**Statement of Environmental Effects
Modification of Land and Environment Court Issued Consent
Proceedings 2020/53946 – Sun Property Northbridge Pty Ltd v Northern
Beaches Council [2021] NSWLEC 1631
Demolition works and construction of 3 separate multi dwelling housing
incorporating an existing heritage building
12 Boyle Street and 307 Sydney Road, Balgowlah**

1.0 Introduction

2.0 Detail of Modifications Sought

Figure 1 - Plan extract showing a comparison between the approved and modified building heights

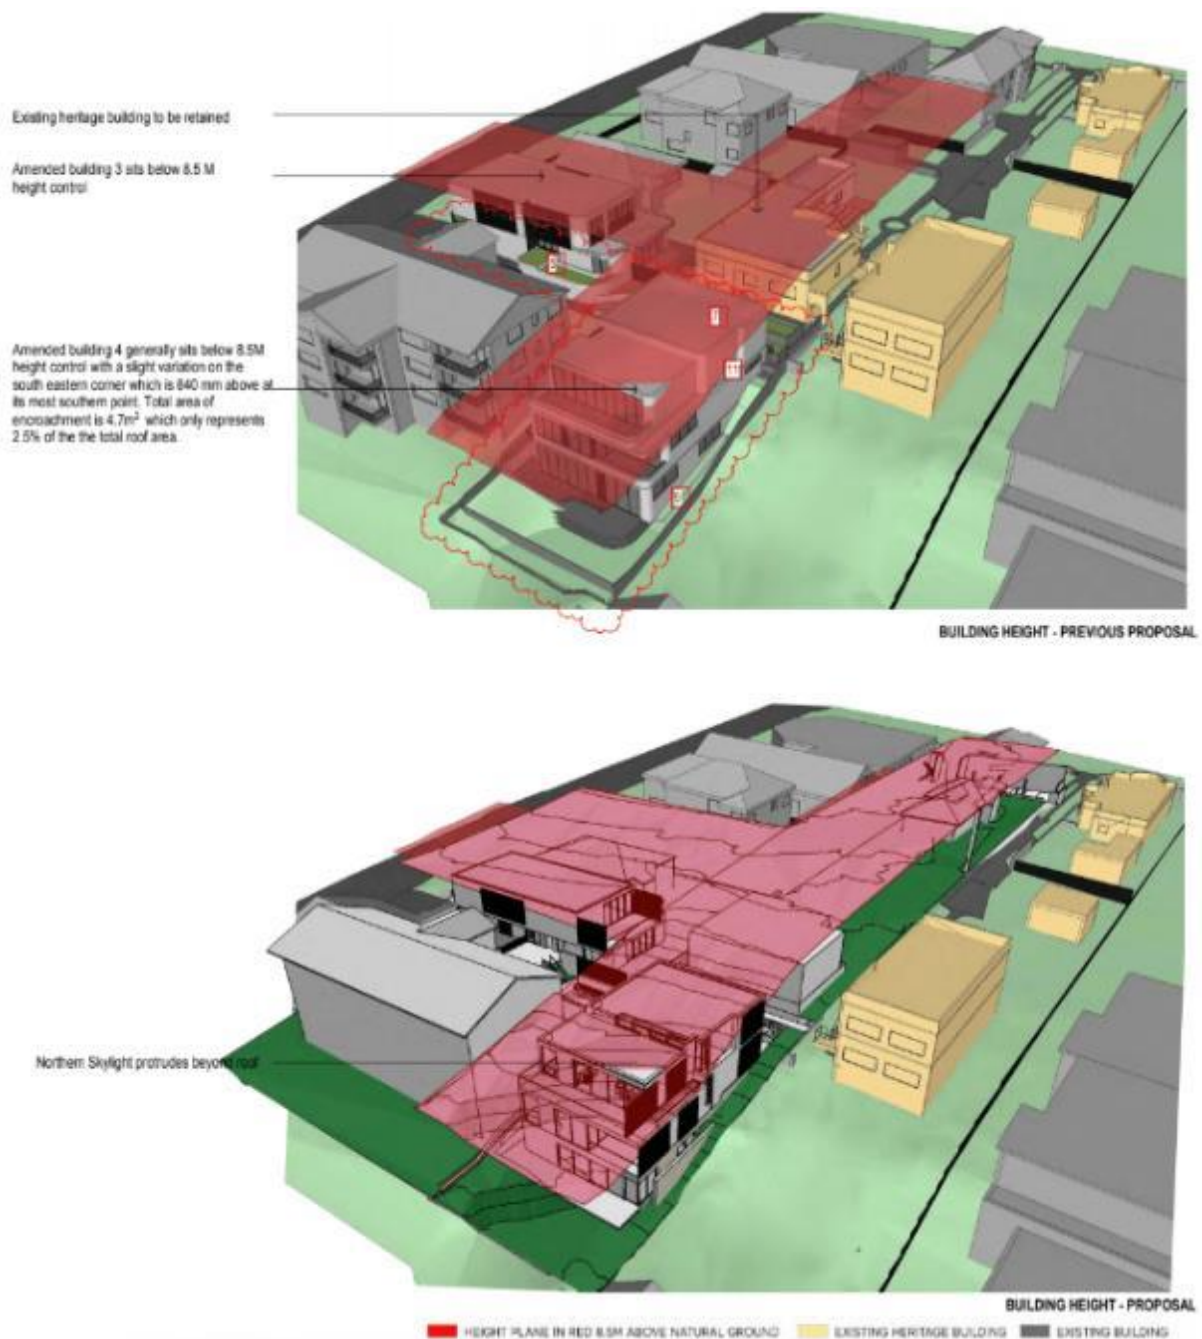
Pursuant to Clause 4.3 of MLEP 2013, the height of a building on the subject land is not to exceed 8.5 metres in height. We confirm that the approved building heights are not materially altered with the development continuing to sit comfortably below the 8.5 metre height standard with the exception of the south-eastern corner of the rear pavilion which continues to breach the 8.5 metre building height standard as depicted in the comparative building height analysis at Figure 1 below.

Comment: The minor building height breaching roof element can be directly attributed to the topography of the site which falls away steeply towards the site's southern boundary with the balance of the development sitting comfortably below the 8.5m height of building development standard. Notwithstanding the minor building height breach, the building height and flat roof form proposed is responsive to/ consistent with the topographic landscape and consistent with the anticipated and prevailing building height established by surrounding development including the adjacent residential flat building at No. 10 Boyle Street. Given the location of the minor building height breaching element relative to the public domain the building height breaching element will not be readily discernible as viewed from the street and to that extent will not give rise to inappropriate or jarring streetscape consequences.

- The building height breaching portion of the development has a parapet height of RL 50.5 being 3.36 metres below the parapet of No. 305 Sydney Road being (RL 53.86) which based on available survey information also breaches the building height standard by at least 360mm along its southern edge. There is a general consistency/ compatibility in the building height established between the medium density housing forms proposed on the site and those established at No.305 Sydney Road and No.10 Boyle Street.

- The building height breaching portion of the development, having a maximum RL of RL 50.5, is 130mm above the sill height of the south facing upper apartment windows (RL 50.37) of No. 305 Sydney Road and 3.12 metres above the sill height of the south facing lower-level apartment windows (RL 47.38) at No. 305 Sydney Road. Further, the building height breaching elements are located approximately 15 metres away from the closest point of the south facing windows in the residential flat building at No. 305 Sydney Road.
